INSPECTION REPORT
Sedimentation Structure
J7-J
Black Mesa Mine
Navajo County, Arizona
for
PEABODY COAL COMPANY

Dames & Moore
10139-011-22

**SITE PLAN
J7-J**

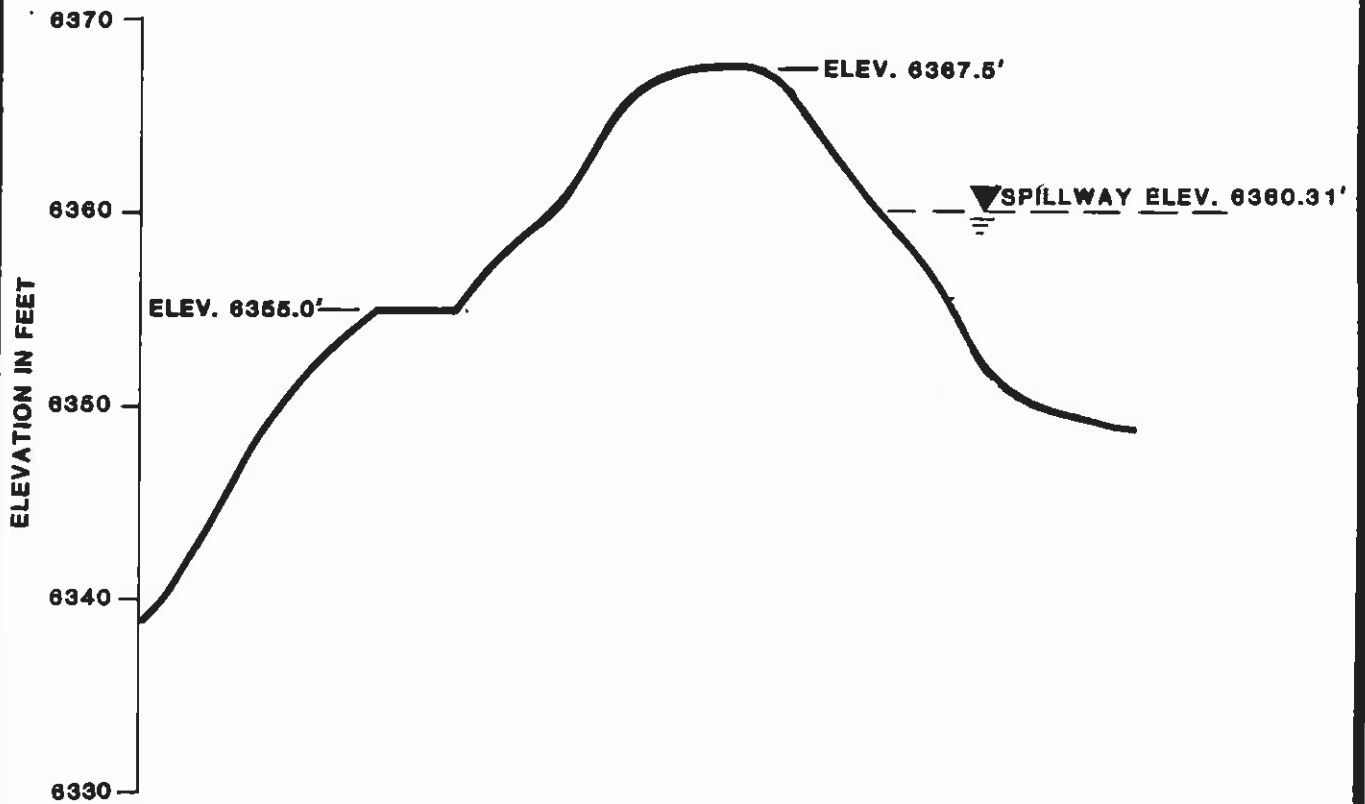
The storage capacity and spillway capacity of Structure J7-J are adequate; however, the spillway does not have an outflow channel. A trapezoidal outflow channel should be constructed along the alignment B-B' shown in Plate 1. The channel profile is shown in Plate 4 and the required dimensions are shown in Plate 5. The outflow channel should be protected against erosion using geotextile and riprap as shown in Plate 5. A trash-rack should be installed on the inlet of the CMP to prevent clogging of the spillway.
